Interim Remedial Measure Design Phase Investigation: Sub-Slab Depressurization System Site C828187

July 2, 2014

Subject: 3750 Monroe Avenue, Site #C828187

**Interim Remedial Measure Design Phase Investigation: Sub-Slab Depressurization System
June 2014**

FIGURE 1

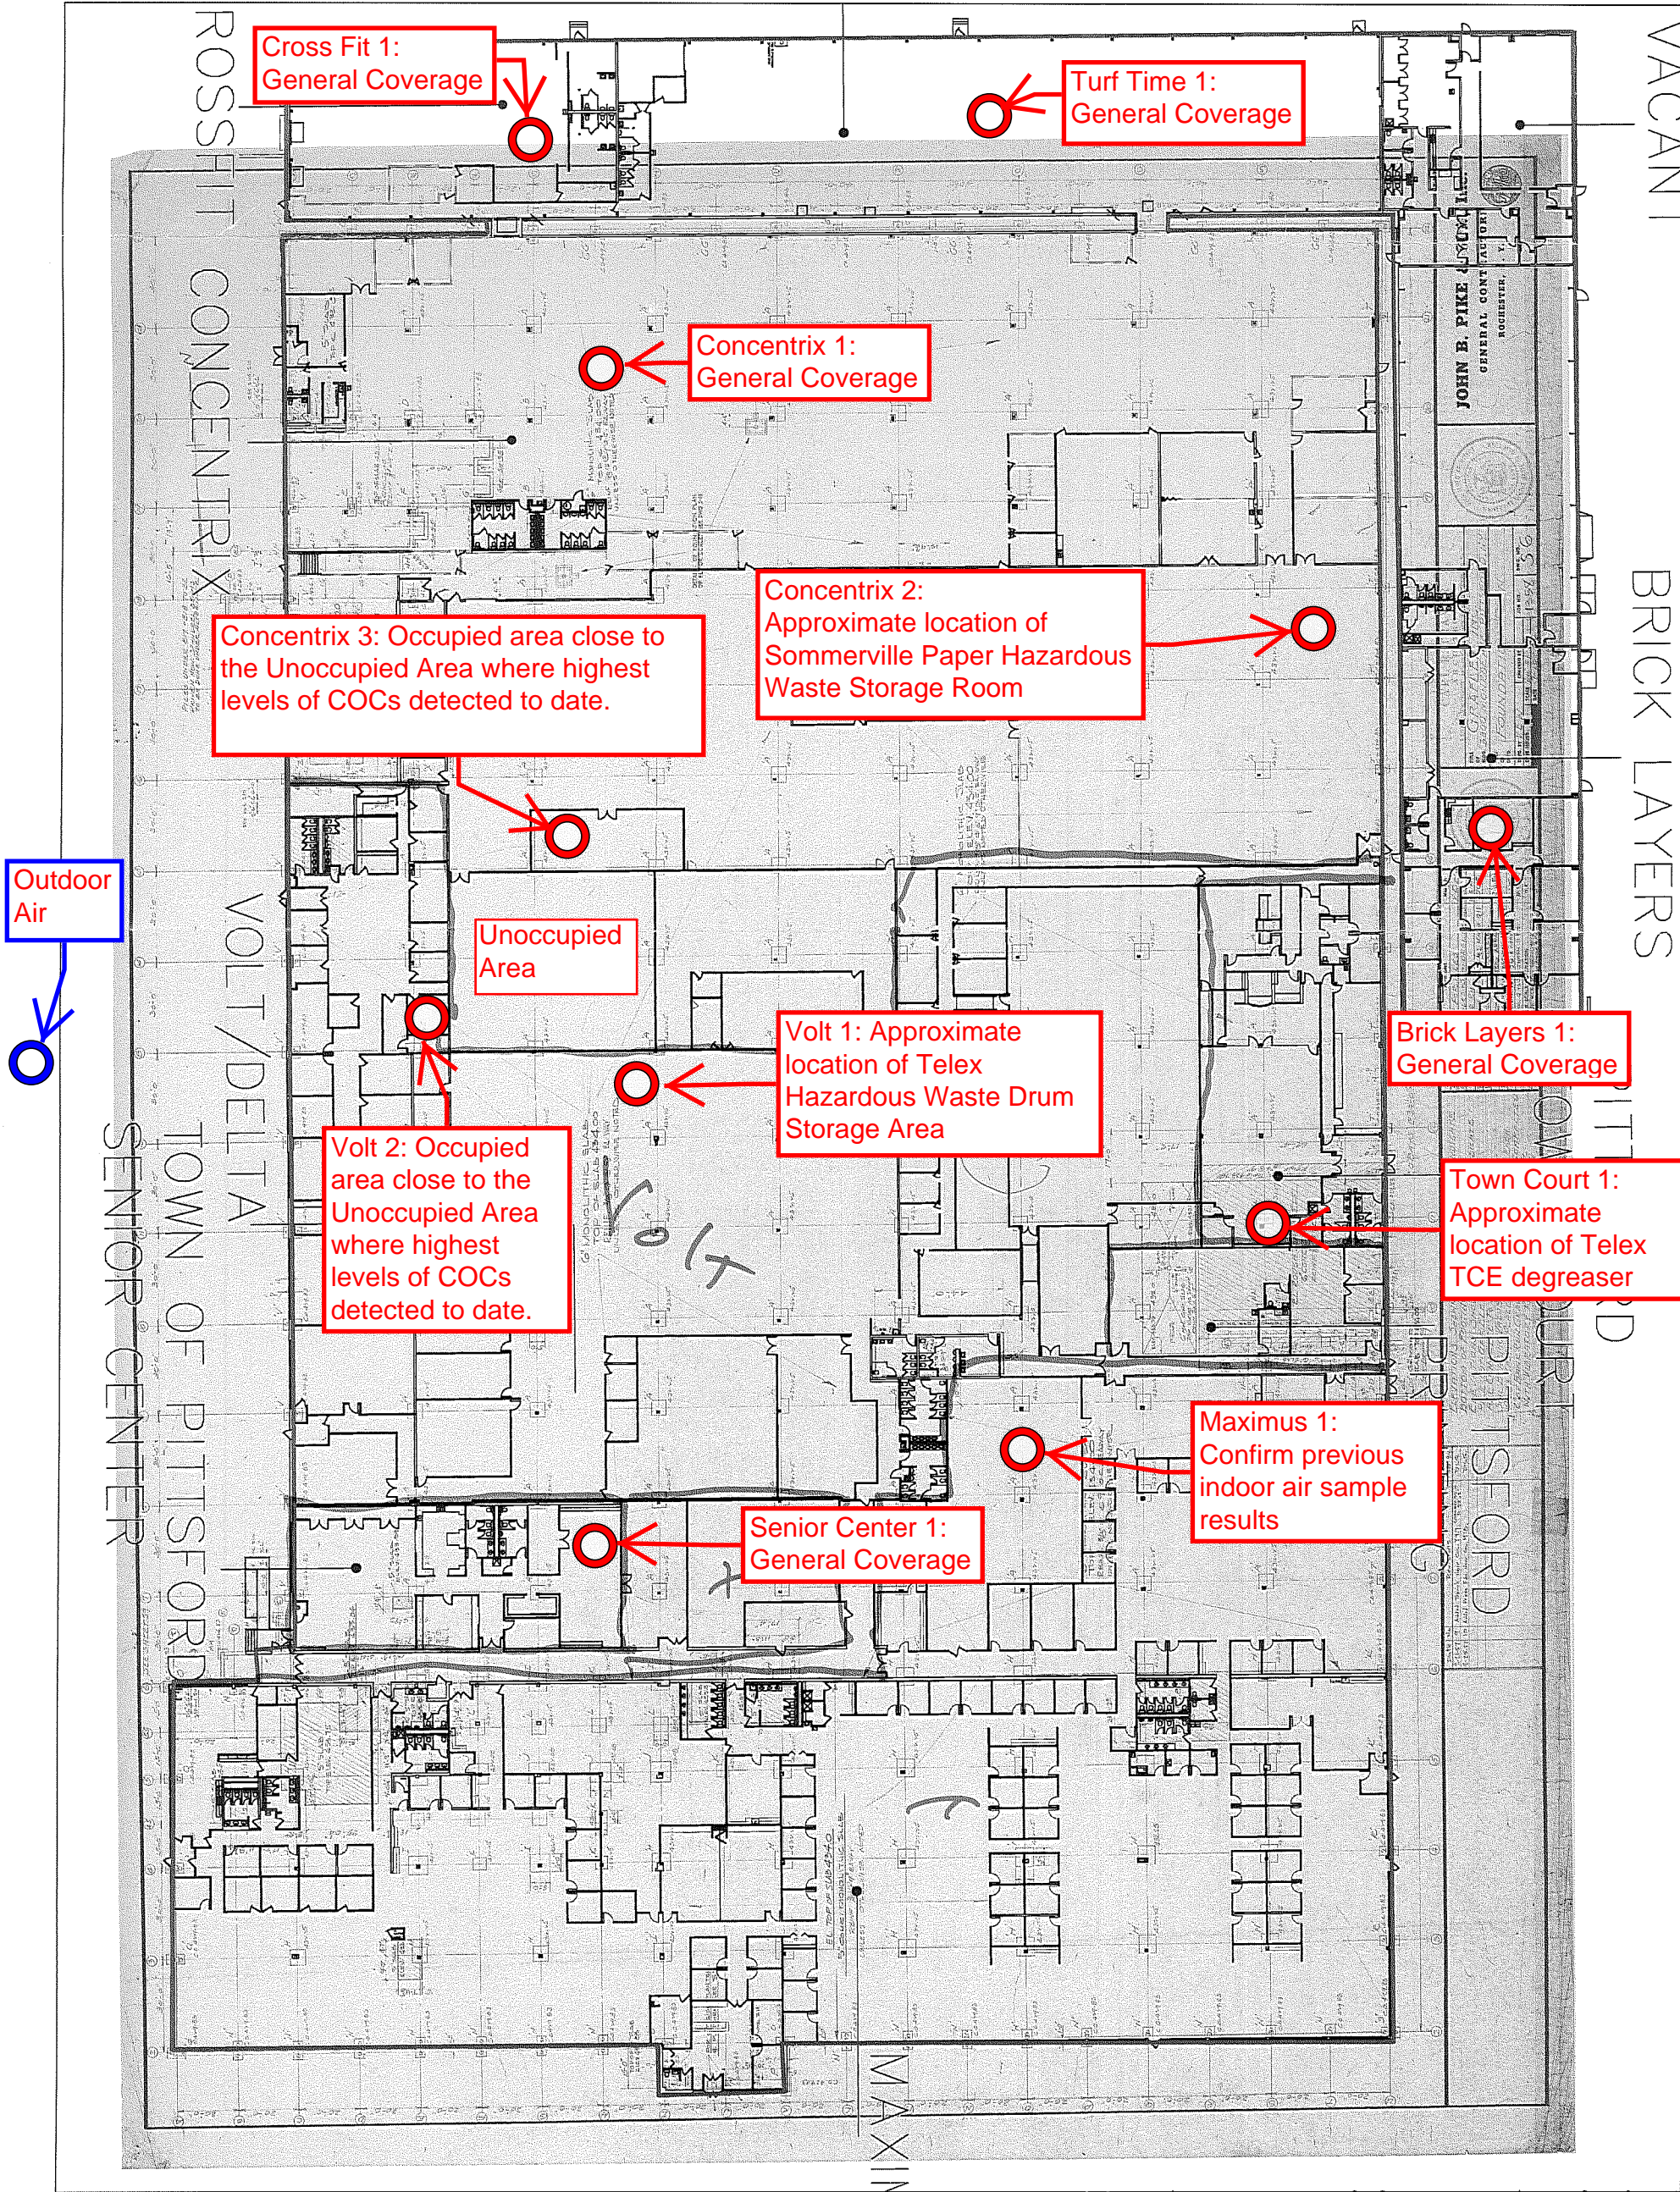
Eleven (11) indoor air samples will be collected with at least one sample being collected from each tenant space except for Pittsford Printing. Approximate indoor air sample locations are provided on Figure 1.

Approximate indoor air sample locations. Final locations to be determined in the field.
